IMPORTANT RECALL INFORMATION #70219

SUBJECT: RECALL CAMPAIGN #70219
American Eagle and American Tradition Battery Seal

**RECALL
BULLETIN:
70219**

SUBJECT:
Installing Battery
Compartment
Seal

Figure 1

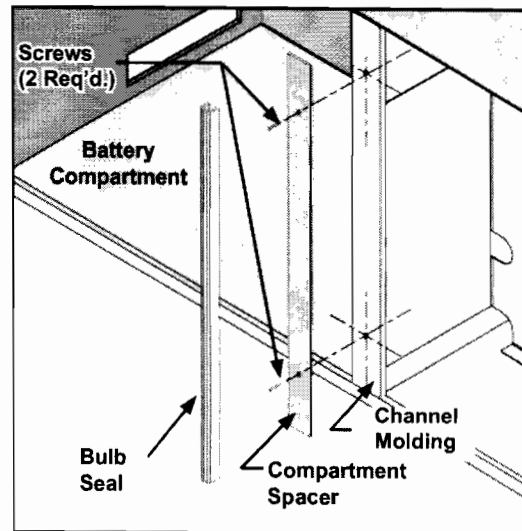
3. Remove the screws fastening the metal channel molding to the edge of the battery compartment wall. (See Figure 1.) Discard the screws.

4. Position the Compartment Spacer so that it is aligned with the channel molding. See Figure 1.
5. Fasten the Compartment Spacer and the channel molding to the end of the compartment wall using screws included with the repair kit. Tighten screws.
6. Prepare the surface of the new Compartment Spacer for application of a bulb seal by wiping with an adhesion promoter, such as Pro-Bond.
7. Remove the protective strip from the back of the new bulb seal and apply the seal to the surface of the Compartment Spacer using firm pressure. Make sure that the bulb seal adheres to all areas of the surface of the Compartment Spacer.
8. Close and open the compartment door to ensure operation and to verify the seal makes contact with the back side of the door. Correct as necessary.
9. Turn on battery disconnects.
